**INACTIVE FLYASH PILE/SOUTH FIELD DISPOSAL
AREA REMOVAL ACTION WORK PLAN FEMP
REVISION 2 DECEMBER 1991**

INACTIVE FLYASH PILE/SOUTH FIELD DISPOSAL AREA

REMOVAL ACTION

WORK PLAN

FIGURE 2-2D BOREHOLE SAMPLE LOCATIONS IN THE FLYASH AREA

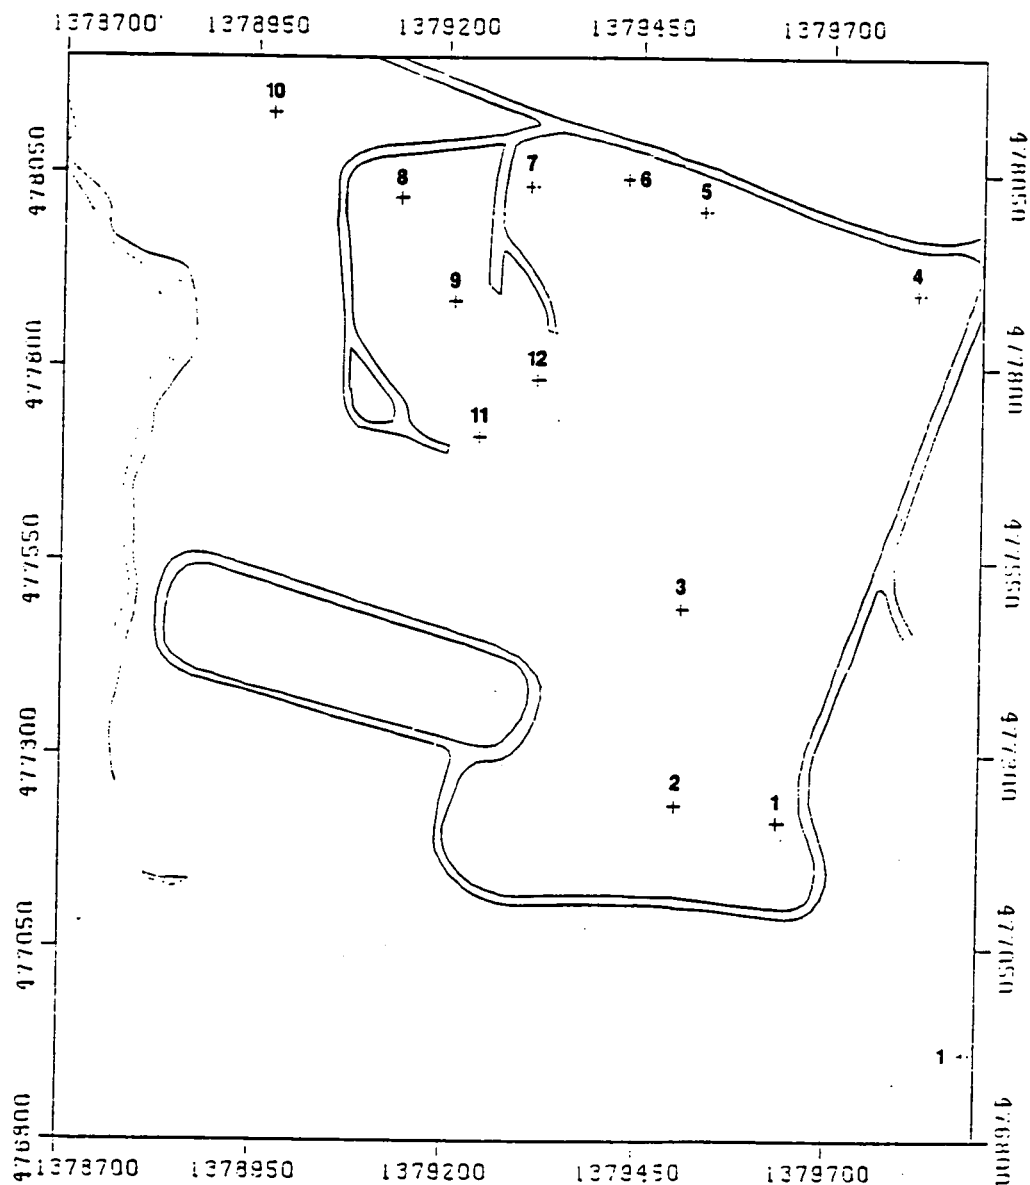
DOE should include a map of the Bore Hole and Surface Sampling locations.

Maps taken from the Weston CIS of the sample locations are included as Attachment A.
